## **Pilot Region-Based Optimization Program for Fund-Lead Sites in EPA Region 3**

### **Site Optimization Tracker: Hellertown Manufacturing Hellertown, Pennsylvania**

HELLERTOWN MANUFACTURING COMPANY SUPERFUND SITE  
HELLERTOWN, PENNSYLVANIA

Report of the Remediation System Evaluation,  
Site Visit Conducted at the Hellertown Manufacturing Superfund Site  
June 5, 2001

## Capture Zone Width Calculation, One Extraction Well

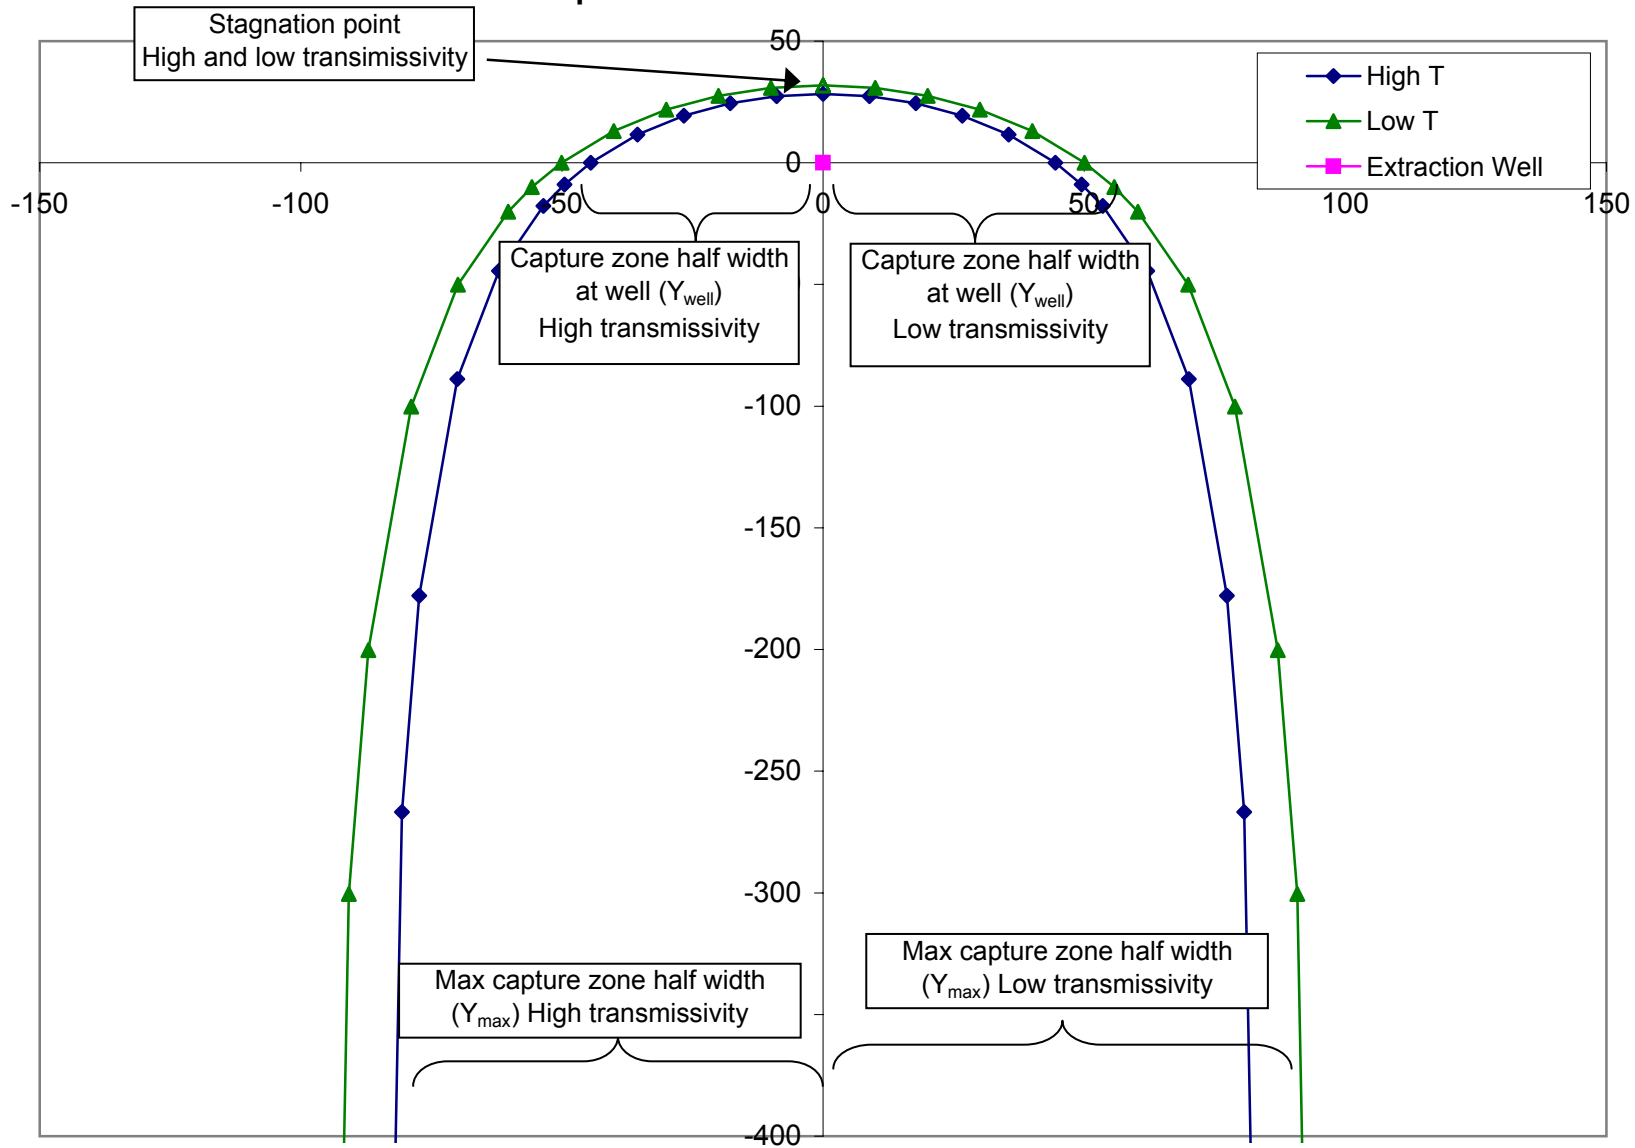
2. When installing the new wells downgradient of the extraction well, the wells should be placed beyond the stagnation point of the capture zone. The calculations in Appendix A suggest a range of likely locations for the stagnation point when pumping at 135 gpm, assuming the aquifer is 200 feet deep, there is a hydraulic gradient of 0.03 feet per foot, and the transmissivity ranges from approximately 4,300 to 4900 ft<sup>2</sup> per day (high and low estimates from site documents). The calculations suggest that the stagnation point is at 28 to 32 feet downgradient of the extraction well. The transmissivity could easily fall outside of the above-mentioned range. To be conservative, it is suggested that the site team place the proposed monitoring wells at least 100 feet downgradient of the extraction well. Based on site maps and discussions during the followup meeting on 12/16/04, the proposed locations indicated are much further downgradient and should be sufficiently conservative to avoid installing the new monitoring wells within the capture zone.

The spreadsheet and chart on the following pages calculates the estimated distance between the extraction well and the capture zone stagnation point.

Capture Zone Width Calculation Results (Low T)			
Input Parameters		Output Parameters	
Transmissivity T (ft <sup>2</sup> /day)	4325	Stagnation Distance X <sub>0</sub> (ft)	-31.88
Pumping Rate Q (gpm)	135	Max Capture Half Width Y <sub>max</sub> (ft)	100.14
Pumping Rate Q (ft <sup>3</sup> /day)	25,900	Capture Half Width at Well Y <sub>well</sub> (ft)	50.07
Hydraulic Gradient i (ft/ft)	0.03

Capture Zone Width Calculation Results (High T)			
Input Parameters		Output Parameters	
Transmissivity T (ft <sup>2</sup> /day)	4871	Stagnation Distance X <sub>0</sub> (ft)	-28.30
Pumping Rate Q (gpm)	135	Max Capture Half Width Y <sub>max</sub> (ft)	88.92
Pumping Rate Q (ft <sup>3</sup> /day)	25,900	Capture Half Width at Well Y <sub>well</sub> (ft)	44.46
Hydraulic Gradient i (ft/ft)	0.03

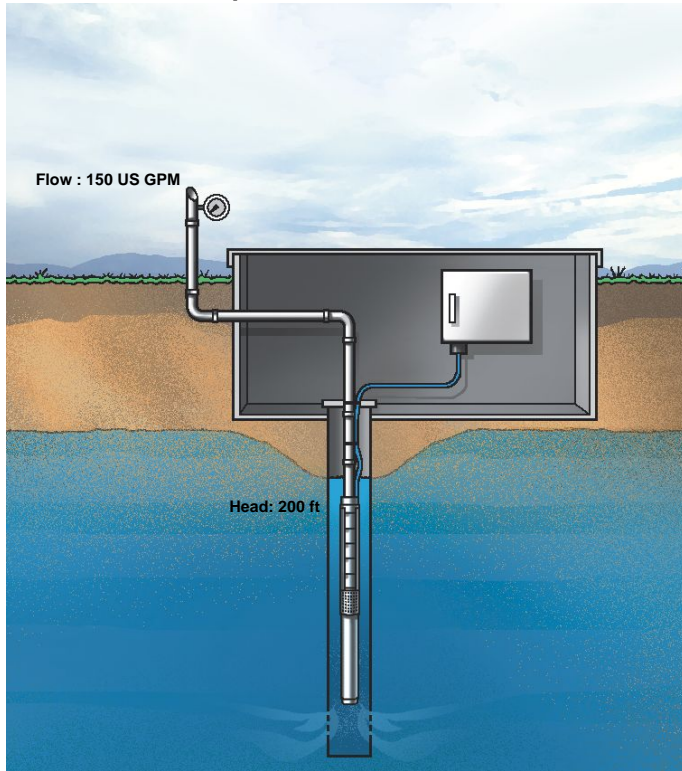
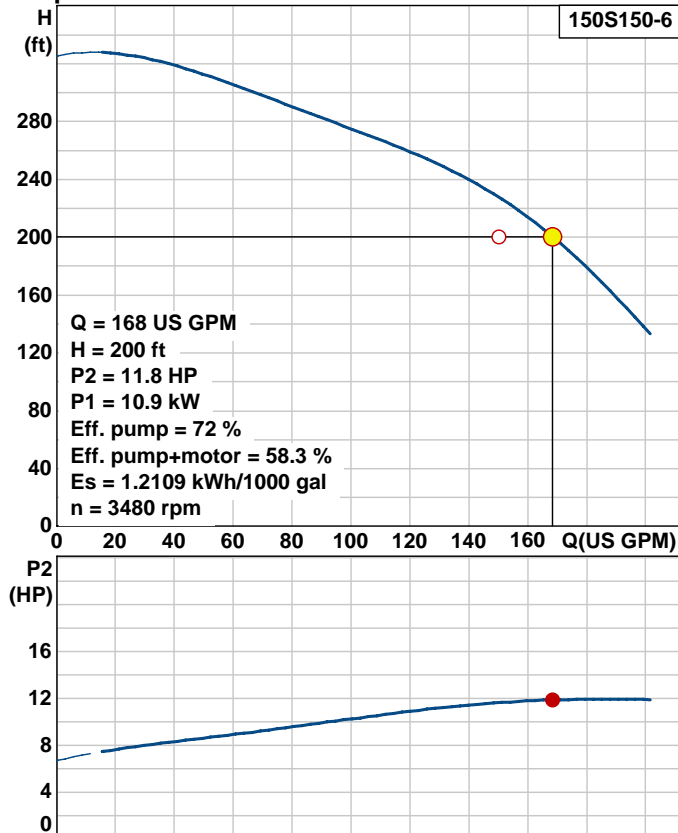
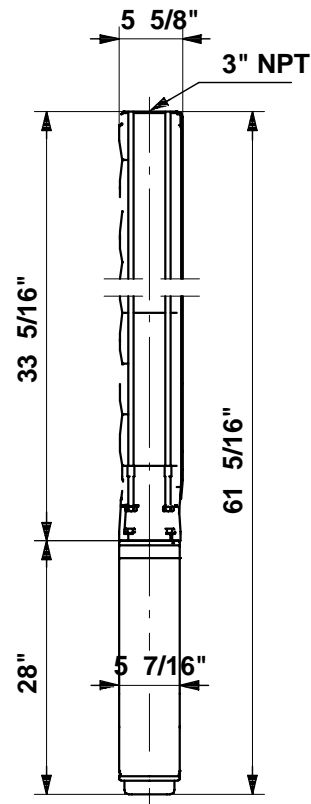
At the request of the RPM, information on a replacement pump is provided in Appendix A.

*Information regarding replacement pumps for the extraction well*

A contact from Pumps-On-Line (877-863-5360), provided a quote of \$2,800 (for pump and motor) delivered to the site via common carrier. Please note that the attached quote of \$4,320 is the Grundfos list price and that the \$2,800 reflects a discount offered by the vendor. Actual installation costs would be somewhat higher, but should be under \$10,000. A comparable Goulds pump (6DLC020 or 150L15 6 stage) was not available from the same vendor, but list prices quotes obtained directly from Goulds ranged from \$4,000 to \$4,700.

**FIGURE 1-1. SITE LAYOUT SHOWING THE LOCATIONS OF THE MONITORING WELLS AND THE EXTRACTION WELL.**

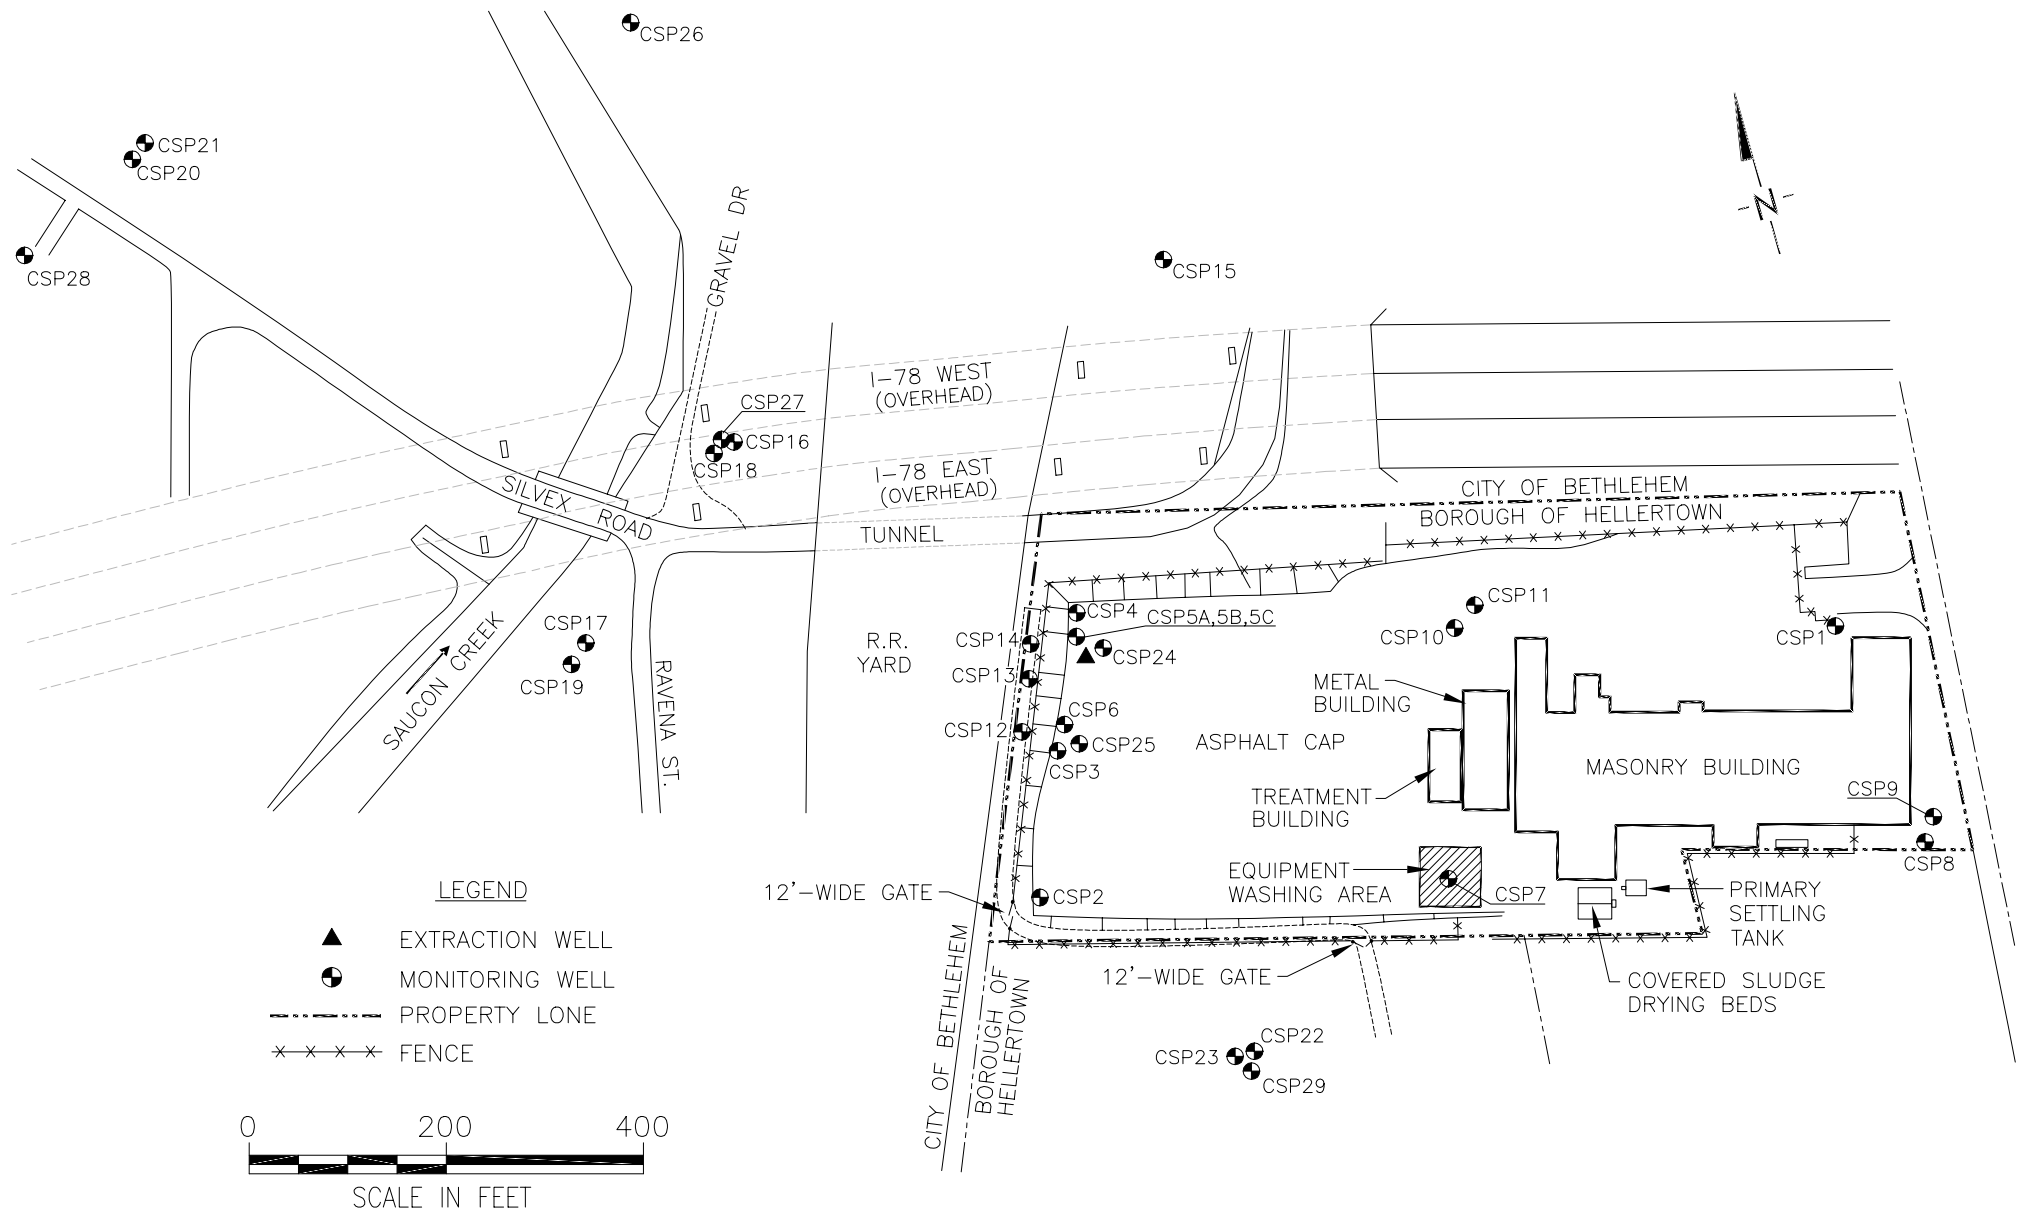
The November 2000 water levels provide sufficient information from the shallow bedrock wells to suggest that ground water in the shallow bedrock near wells CSP-12, CSP-13, CSP-14, and CSP-5A is captured by the extraction well. Data is too sparse to estimate ground water directions and capture in the overburden and the deep bedrock or in the shallow bedrock further from the extraction well. Because no monitoring wells or water-level measurements exist for over 400 feet to the west (downgradient) the extent of contamination and capture is unknown downgradient of CSP-12, CSP-13, CSP-14, and CSP-5A.

Ideally, one or more monitoring wells in the shallow bedrock should be added between CSP-14 and Saucon Creek, to allow increased resolution for water level evaluation as well as water quality evaluation. The ability to add one or more wells in that area may be hampered by access issues, as well as limitations due to steep slopes immediately west of CSP-14. To add one well should cost approximately \$20,000 in capital costs, and additional sampling and analysis of that well will be less than \$2,000 per year.
